COCKLE BAY PARK REDEVELOPMENT

Appendix H Biodiversity Development Assessment Report Waiver Request

Revision [B]

RE: Biodiversity Assessment – Cockle Bay Park Redevelopment

Figure 3: Cockle Bay Park Site Plan (Henning Larsen & Scott Carver Architects 2020)

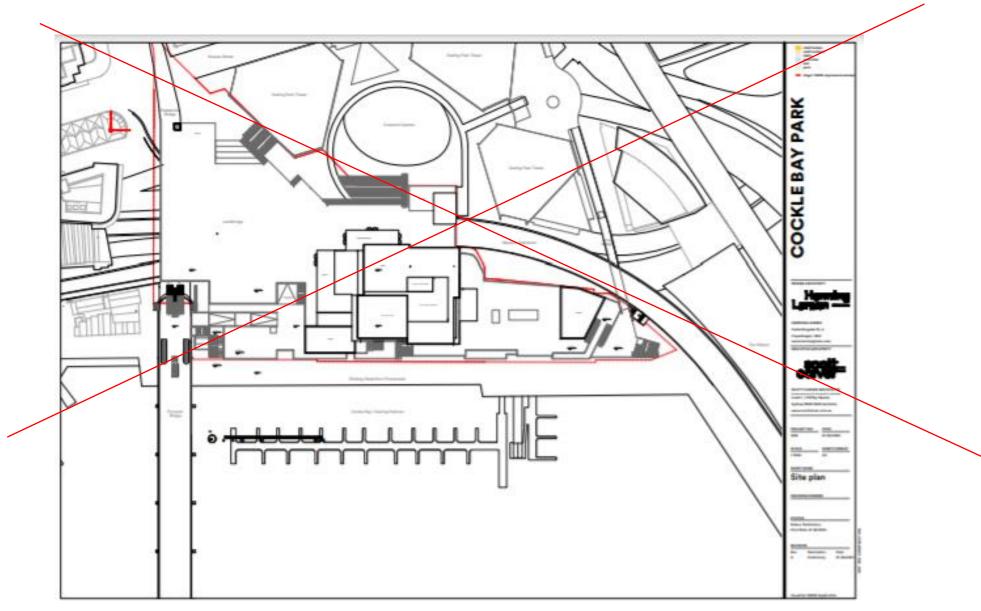
this site plan is very old. Remove
